# UNITED STATES PATENT AND TRADEMARK OFFICE

APPLICATION NO.	FILING DATE	FIRST NAMED INVENTOR	ATTORNEY DOCKET NO.	CONFIRMATION NO.
10/588,402	08/03/2006	Gunther Flattinger	FLATTINGER ET AL - 1 PCT	6943
25889	7590	04/27/2011	EXAMINER	
COLLARD & ROE, P.C. 1077 NORTHERN BOULEVARD ROSLYN, NY 11576			JENNISON, BRIAN W	
			ART UNIT	PAPER NUMBER
			3742	
			MAIL DATE	DELIVERY MODE
			04/27/2011	PAPER

<b>Office Action Summary</b>	<b>Application No.</b>	<b>Applicant(s)</b>	
	10/588,402	FLATTINGER ET AL.	
	<b>Examiner</b>	<b>Art Unit</b>	
	BRIAN JENNISON	3742

2. **Claims 51-58, 60-63, 65, 67-68, 70-79, 80-84, 87-89 stand rejected under 35 U.S.C. 102(b) as being anticipated by Kensrue.**

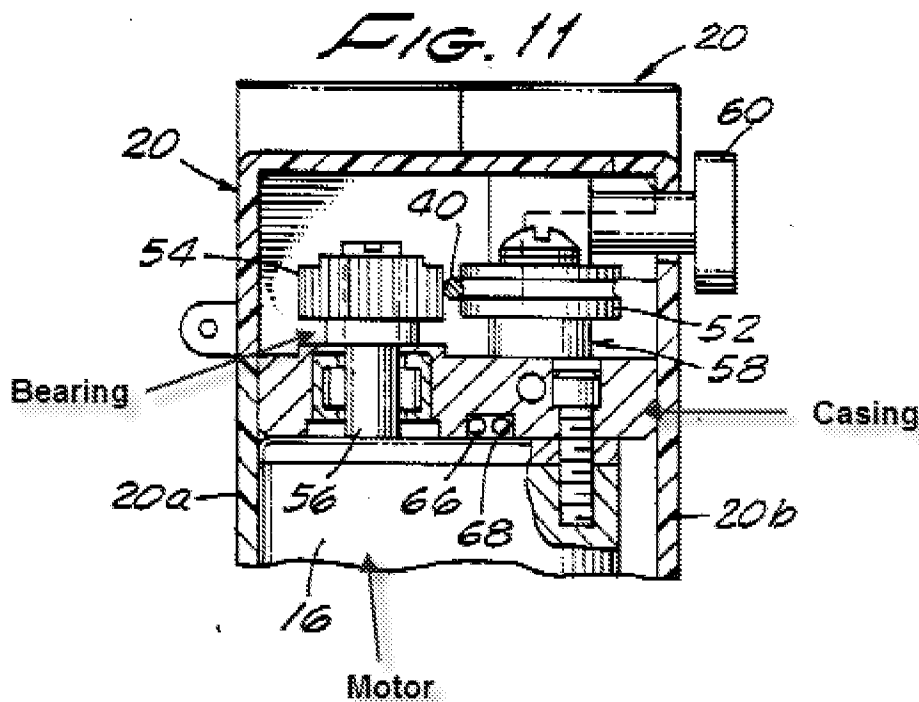
**Regarding Claim 51:** A welding torch including a torch housing, wherein a drive unit formed by at least one drive roller and one pressure roller **(Fig 1 shows a casing or torch housing 20 with a drive roller 54 and a roller 52 for providing pressure.)** As well as a drive motor is arranged in the torch housing for feeding a welding wire, **(Fig 5 shows a drive motor 16 inside the casing 20 for feeding welding wire 40a)** wherein a part of the torch housing is designed as a stator housing of the drive motor of the drive unit, **(Fig 5 shows part of the housing being a stator housing of the drive unit with the stator being inside of the motor 16.)** and bearings are provided on the torch housing to stabilize and position a rotor of the drive motor. **(The motor 16 would contain bearings and a rotating device since it is an electric motor.)** The claim does not specify which part of the housing must be the stator housing. The *part* of the welding gun housing that the stator is located in is considered the part of the housing which is the stator housing. Any Furthermore, no actual stator is even mentioned in the claim just housing for it. **Fig 11 as reproduced below shows a bearing located on the housing.** The motor would comprise stator windings.

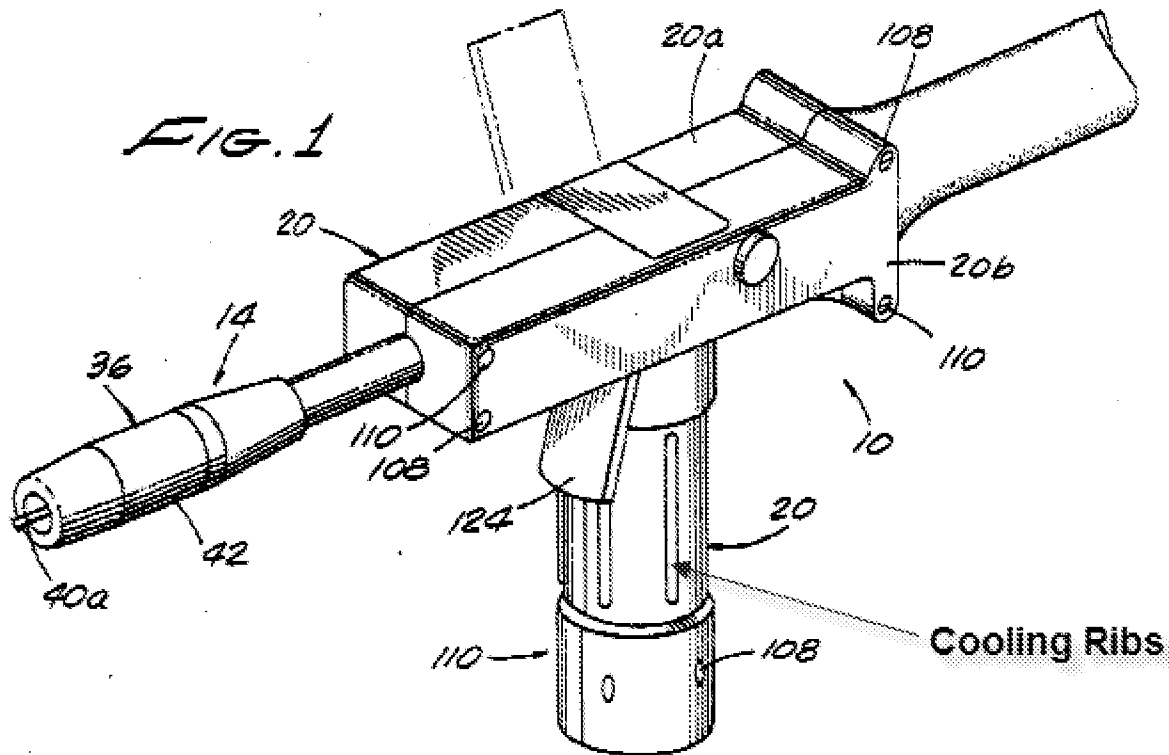
**Regarding Claim 63:** Fig 2 shows a gear around drive roller 54 which is connected to motor shaft 56.

**Regarding Claim 64:** Fig 2 shows roller 54 having a gear around its outside being fastened to the block 12 or intermediate piece.
